Relocation of SR 113 From CR 31 To Richland  
Creek @ Old Alabama Road Relocation – Phase II  
P.I. Nos. 621440 and 621445  
STP00-0179-01(010) and BHF00-0179-01(011)

Value Engineering Study Report

July 2010

AMERICAN ENGINEERS, INC.

R-9B

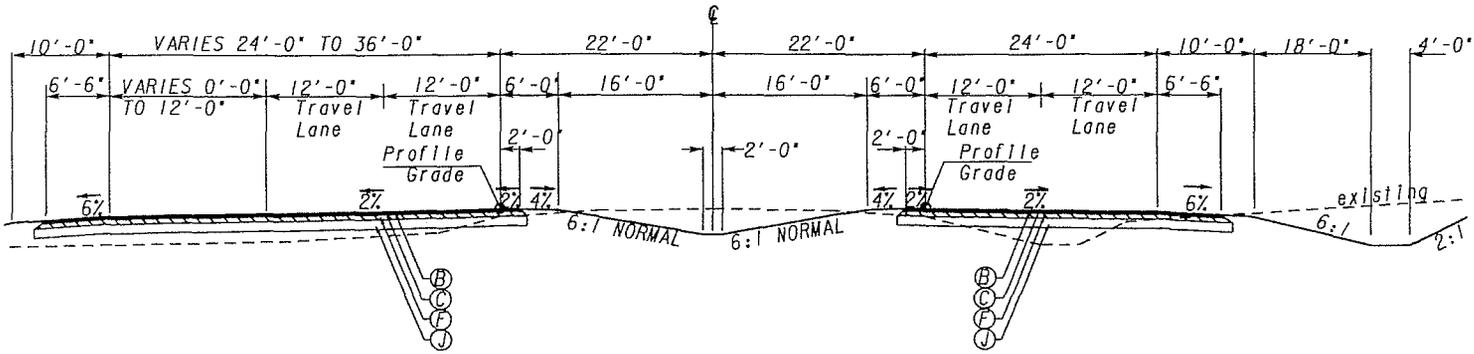
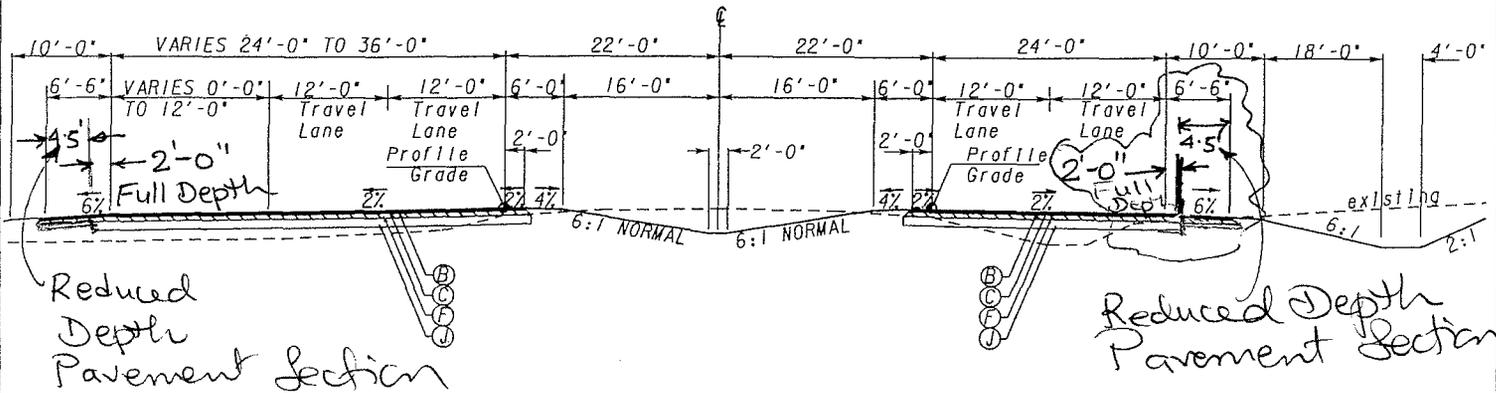
AS DESIGNED

DESCRIPTION: **AT THE CR 533 INTERSECTION WITH SR 113, CHANGE FROM A TYPE B MEDIAN CROSSING TO A TYPE A MEDIAN CROSSING**

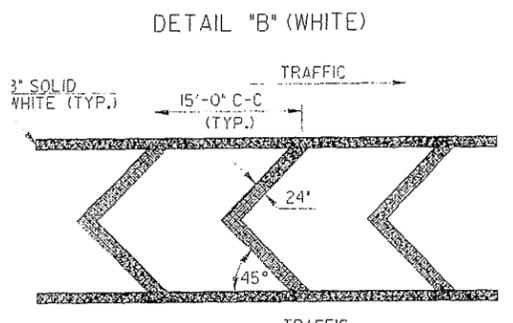
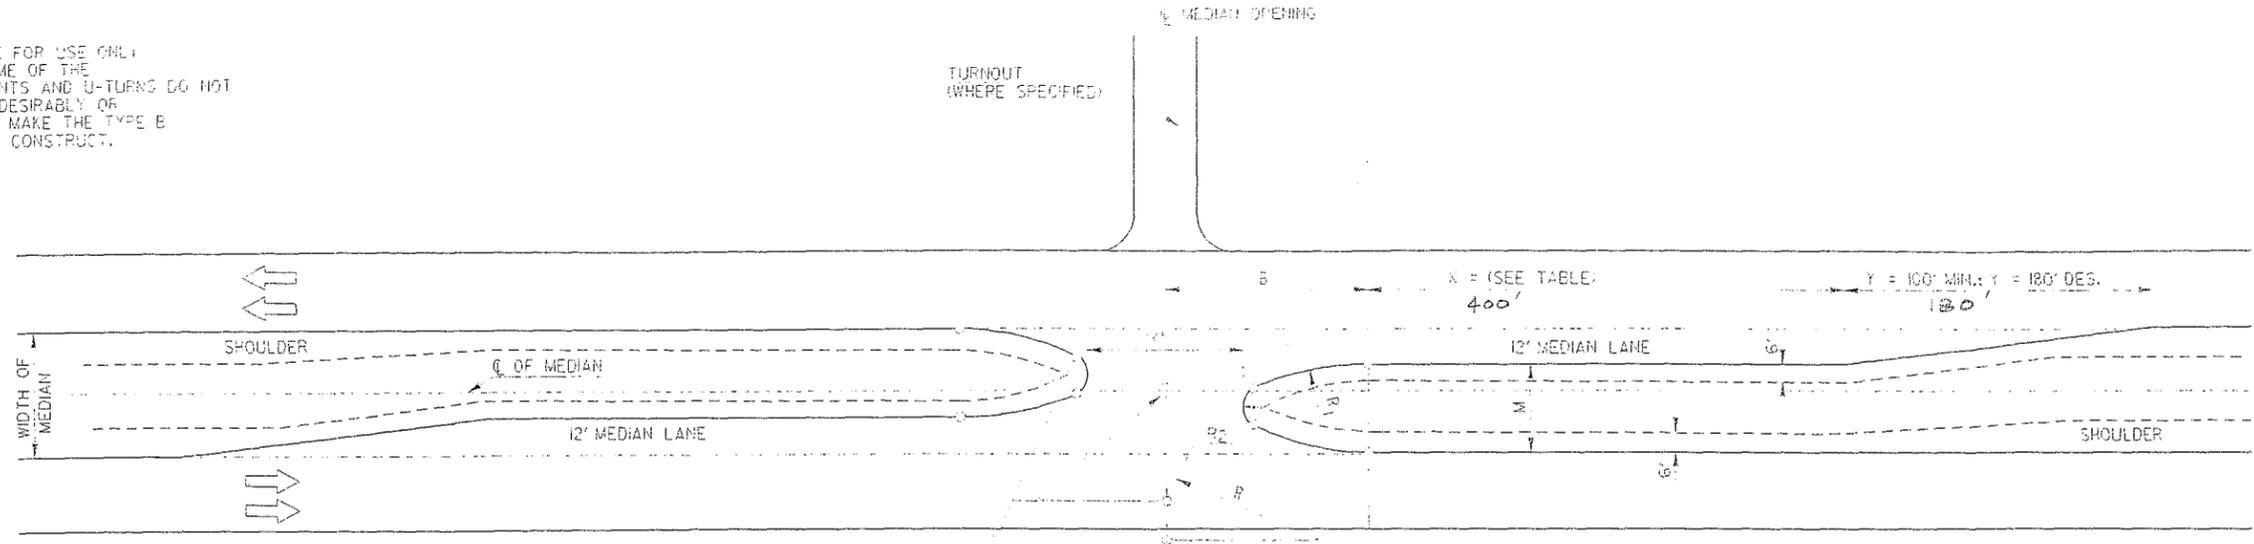
There are no traffic counts for this intersection. Because CR 533 is believed to be a minor road with very little traffic, the recommended 20 vehicle per hour (vph) combined left turning movements maximum for a Type A median crossing in the GDOT standard will probably be met. Thus it is suggested that the Type A median crossing will be adequate in this location and substantial construction and maintenance costs can be saved.

DESCRIPTION: **AT THE FRICTION DRIVE INTERSECTION WITH SR 113, CHANGE FROM A TYPE B MEDIAN CROSSING TO A TYPE A MEDIAN CROSSING**

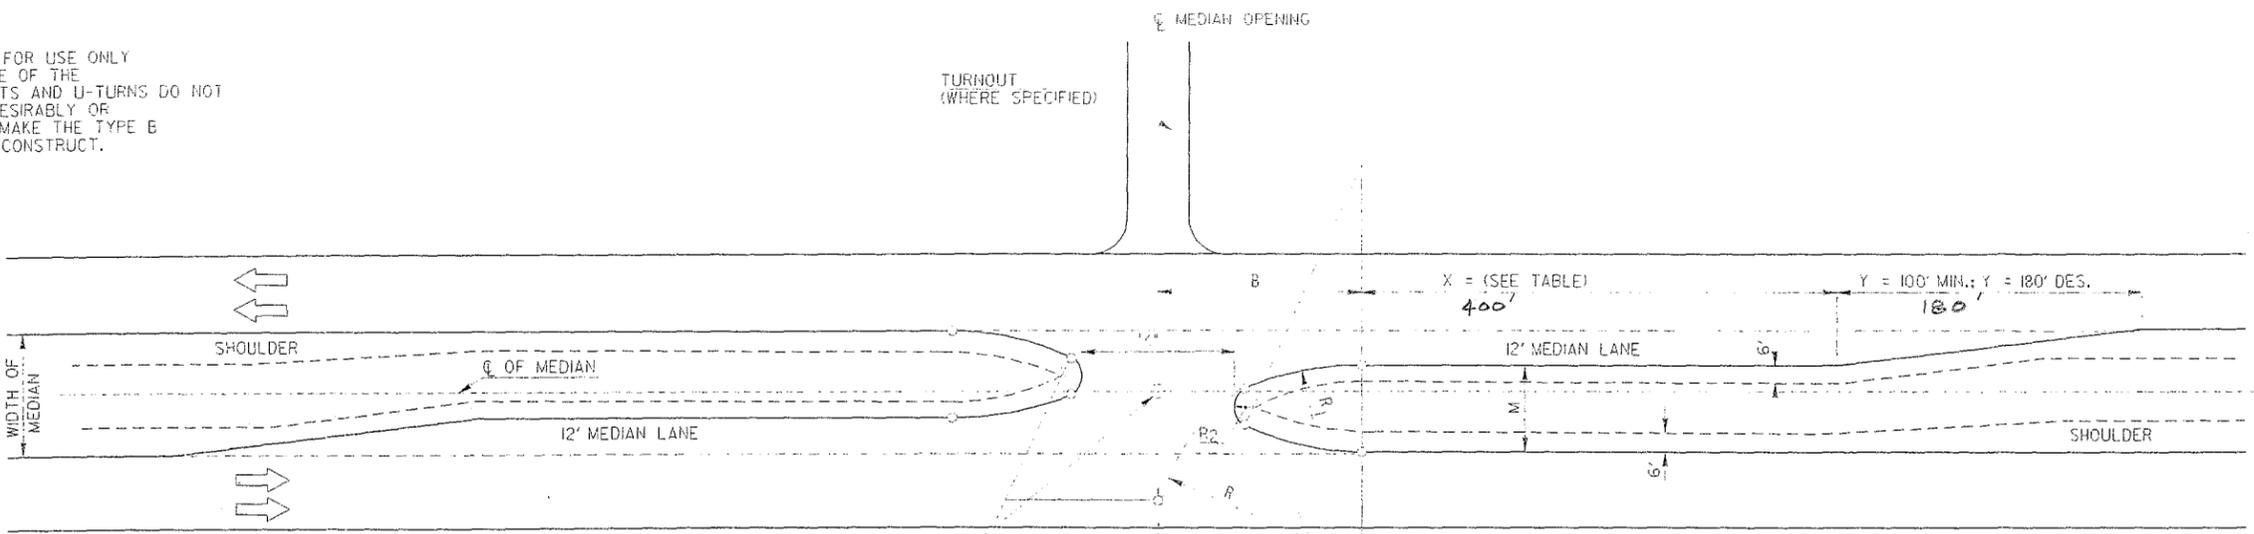
There are no traffic counts for this intersection. Because Friction Drive is believed to be a minor road with very little traffic, the recommended 20 vehicle per hour (vph) combined left turning movements maximum for a Type A median crossing in the GDOT standard will probably be met. Therefore, it is suggested that the Type A median crossing will be adequate in this location and substantial construction and maintenance costs can be saved.

PROJECT: **SR 113 FROM OLD ALABAMA ROAD RELOCATION TO SR 61 @ NEW ALIGNMENT – PHASE I** ALTERNATIVE NO.:  
*P.I. No. 0008382; CSSTP-0008-00(382)* **R-8**  
*Bartow County, GA*

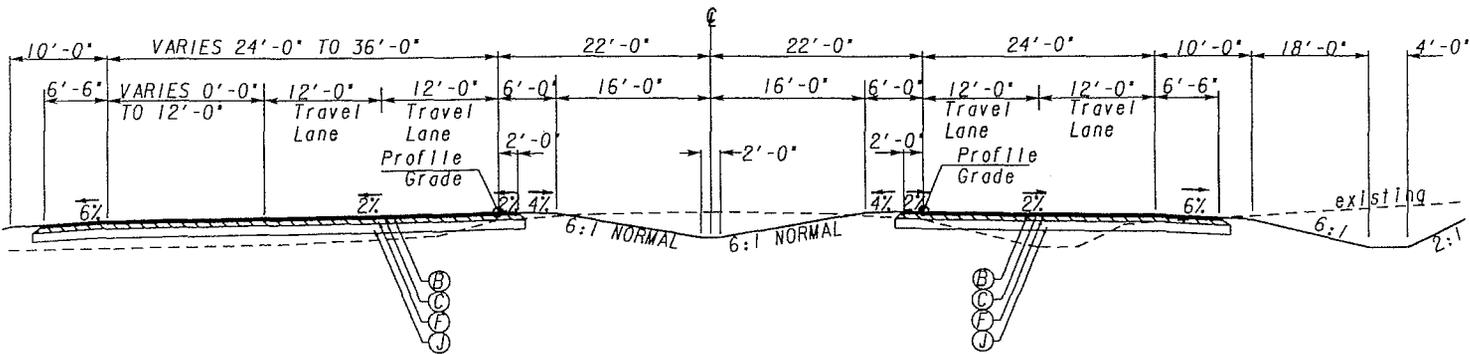
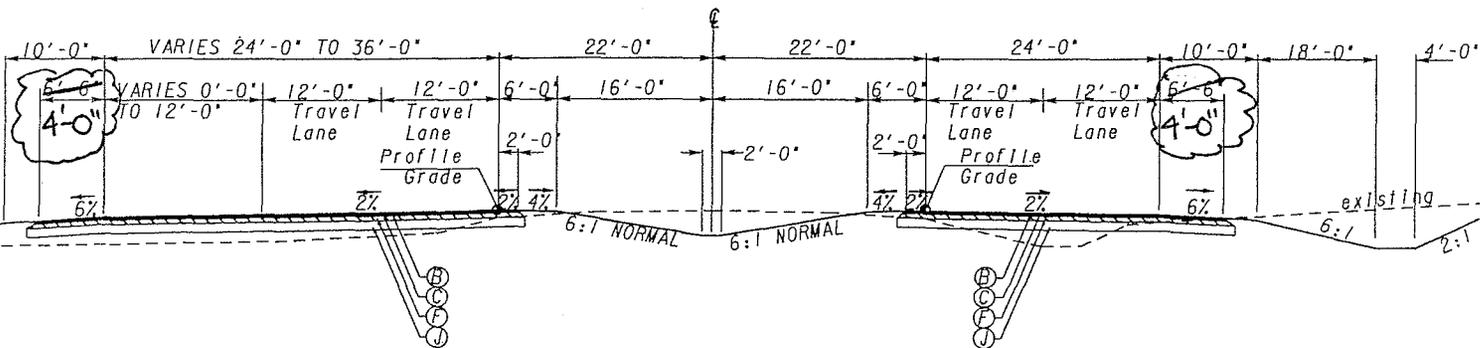
AS DESIGNED

ALTERNATIVE

DESCRIPTION: **REPLACE THE TWO CONCRETE BOX CULVERTS WITH REINFORCED CONCRETE PIPES**

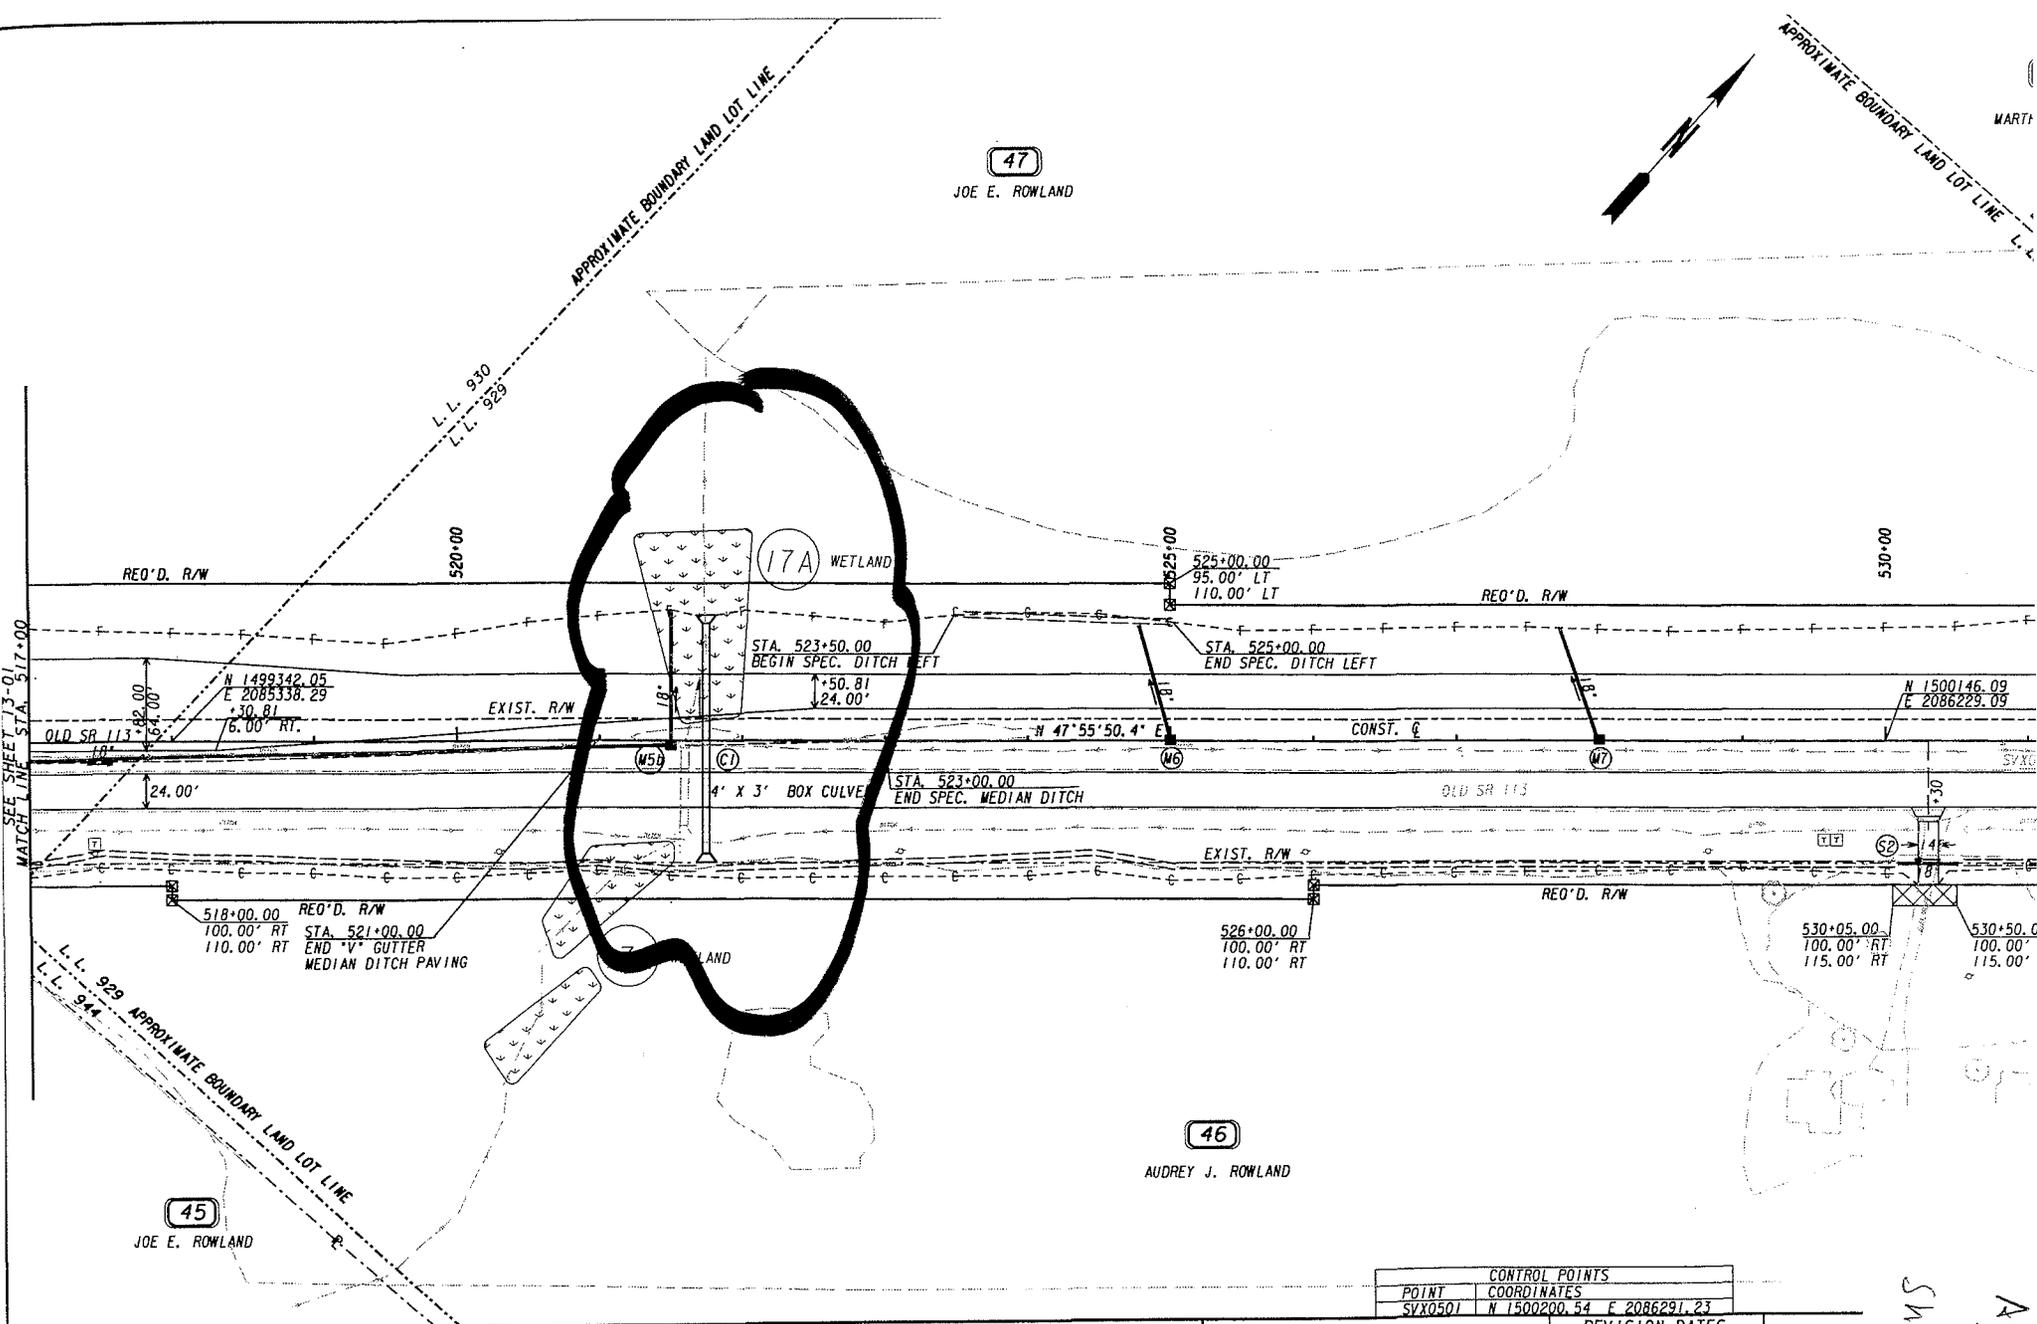
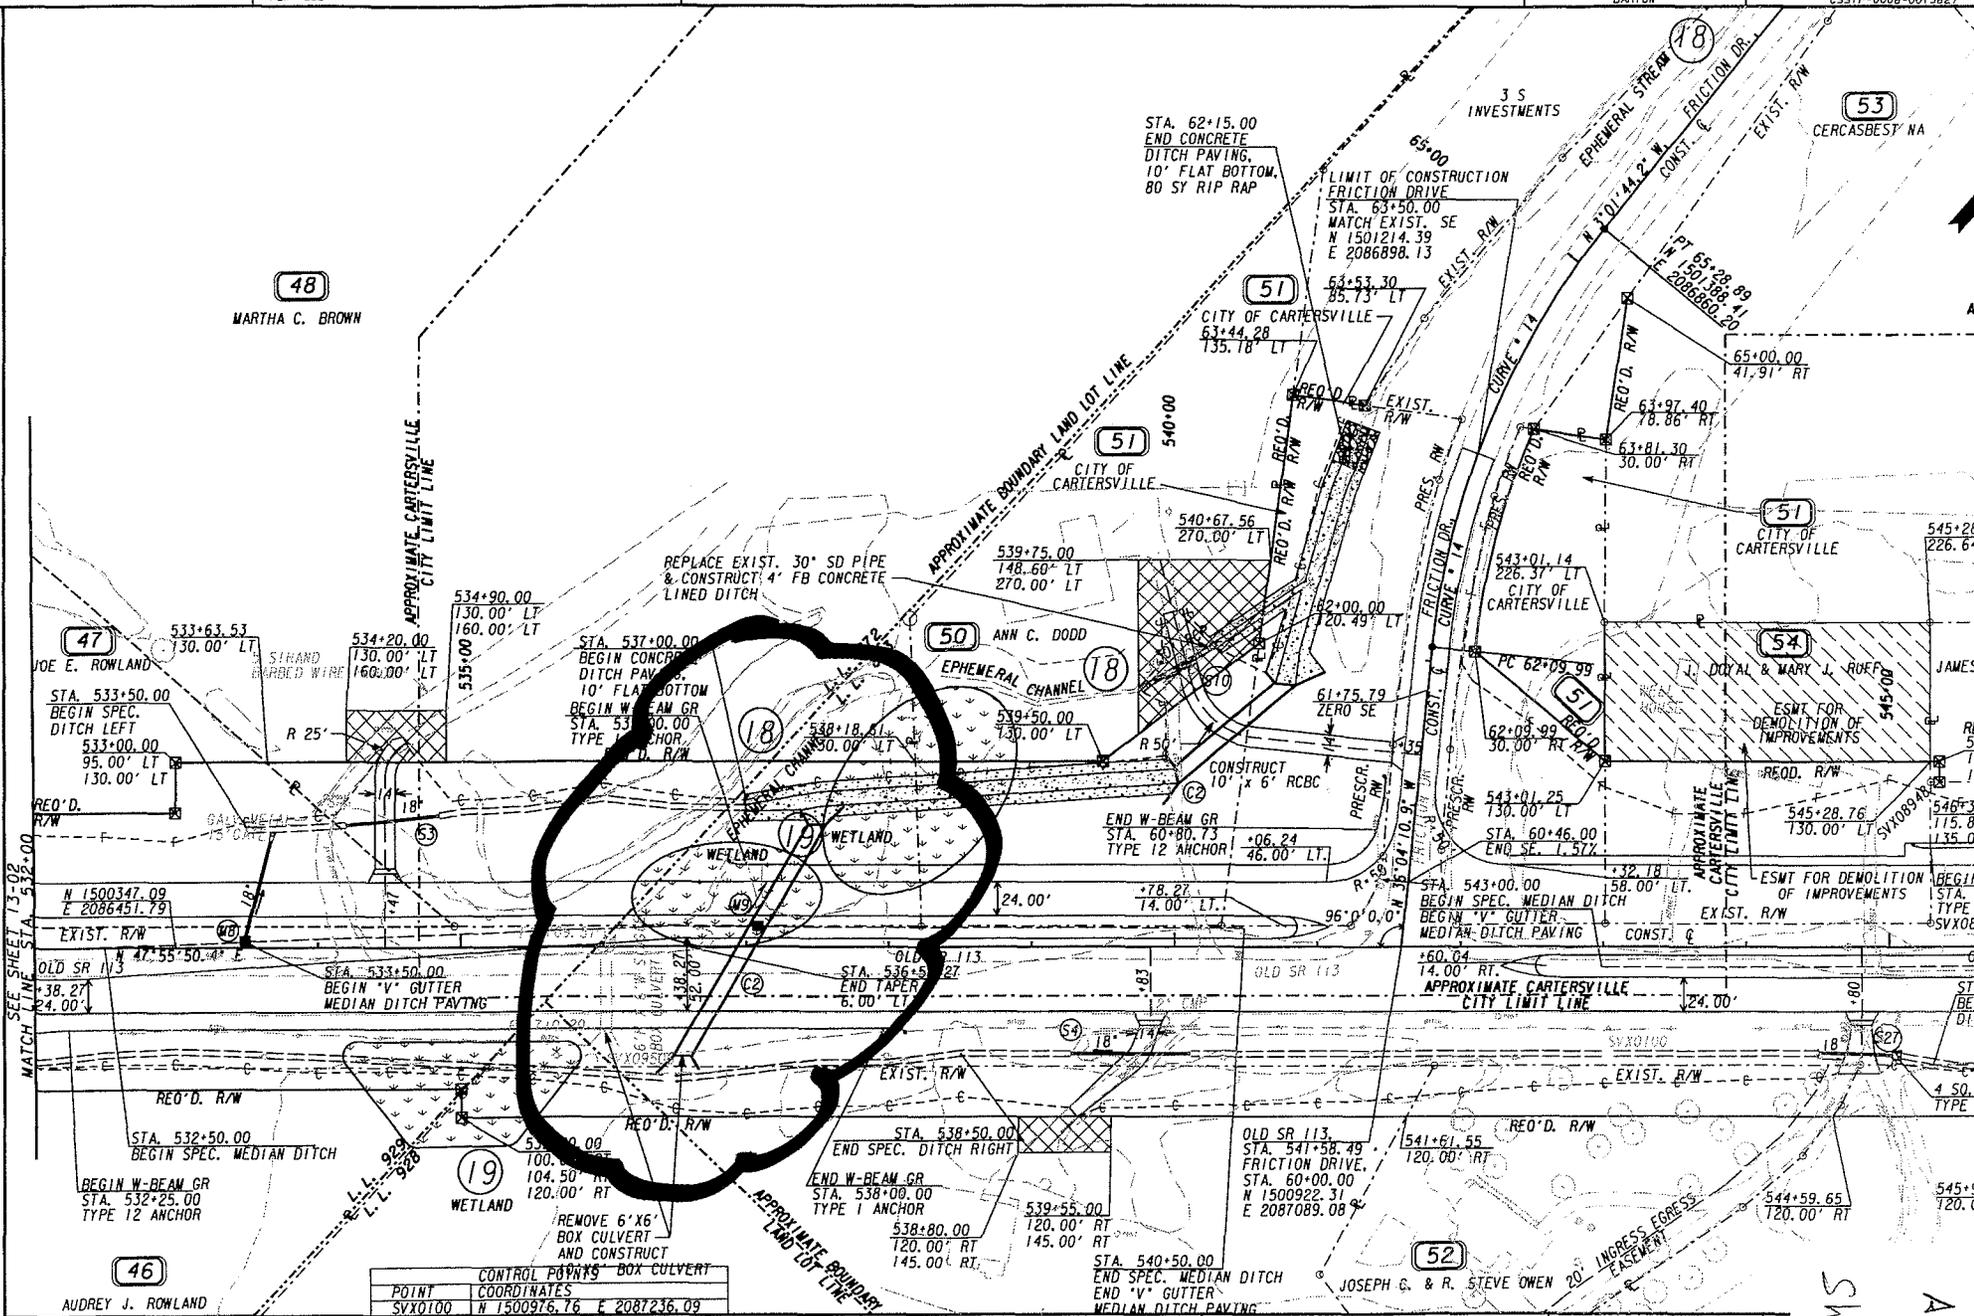
Replace the 4-ft. x 3-ft. x 160-ft.-long concrete box culvert with a 48-in.-diameter reinforced concrete pipe (RCP).

Replace the 10-ft. x 6-ft. x 190-ft.-long concrete box culvert with dual 78-in.-diameter RCPs.
